# Land Grid Arrays (LGAs) and Field Programmable Gate Arrays (FPGAs)

## Major Design and Supply Chain Changes

NEPP Electronics Technology Workshop June 11, 2013

# Virtex-4 and Virtex-5 QV FPGA CF Package Assembly Location Change

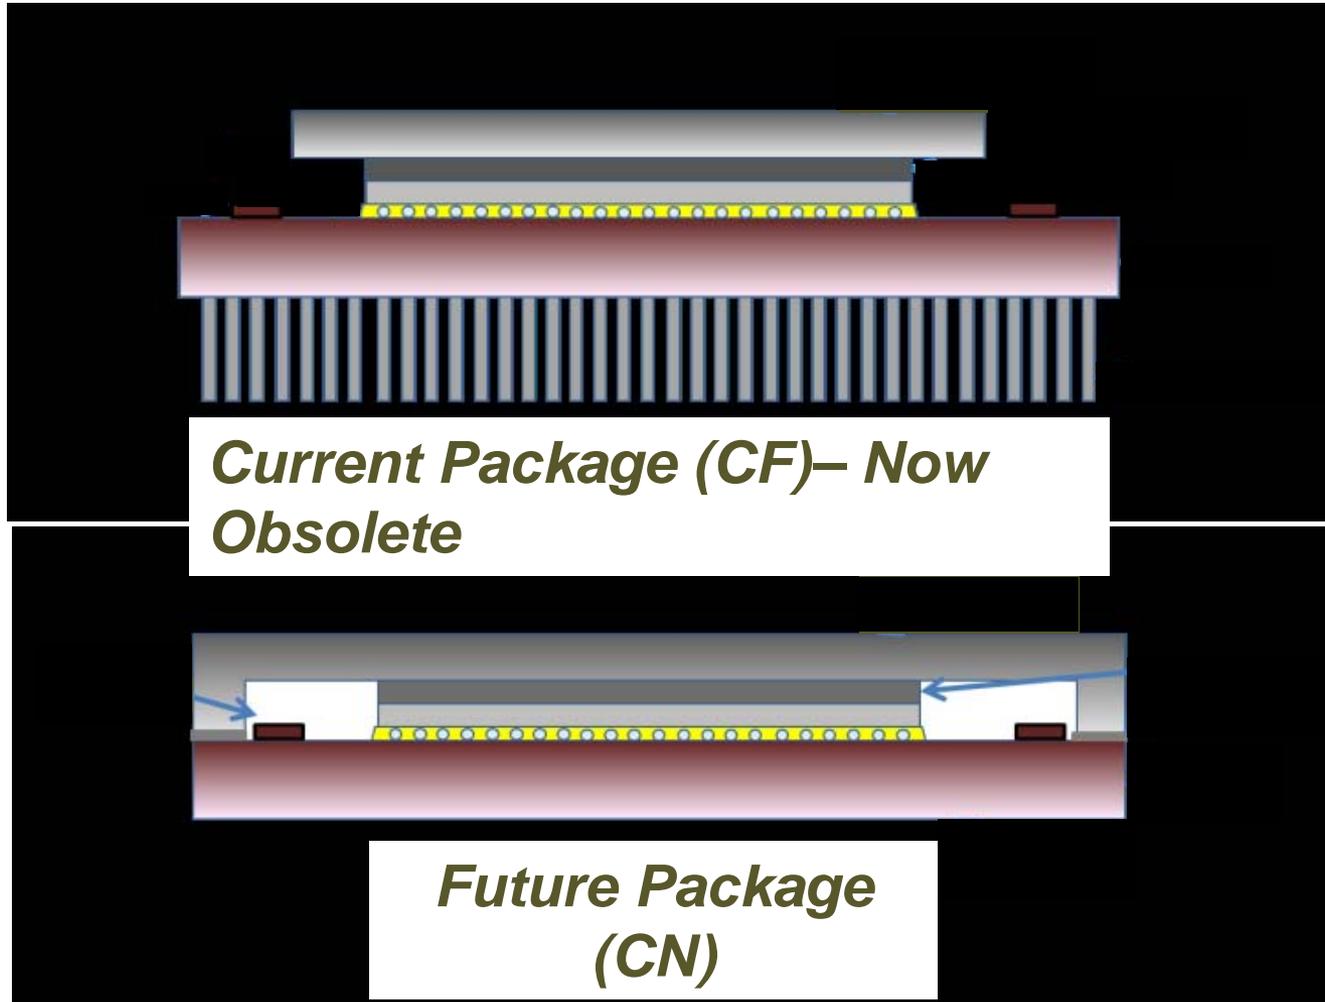
The purpose of this notification is to communicate that Xilinx is discontinuing the current Virtex<sup>®</sup>-4 and Virtex<sup>®</sup>-5 QV FPGA Ceramic Flip Chip Column Grid Array (CF package code) parts due to current supplier line discontinuance. However, Xilinx will continue to offer Virtex-4 and Virtex-5 QV FPGA Ceramic Flip Chip Land Grid Array products under a new CN package code with a new assembly supplier.

Xilinx's supplier, IBM is shutting down their Ceramic Flip Chip assembly line including column attach of the Ceramic Column Grid Array (CCGA). This line shutdown is impacting our Virtex-4 and Virtex-5 QV FPGA ceramic CF package products. To ensure supply continuity, Xilinx is in the process of qualifying a new supplier with new part numbers released for production in CYQ1, 2014.

Virtex-4 and Virtex-5 FPGA QV Ceramic Flip Chip will be offered in Land Grid Array products (without columns) will be qualified with a new Bill of Material (underfill, lid and lid attach adhesive, eutectic bumps) at the new assembly supplier.
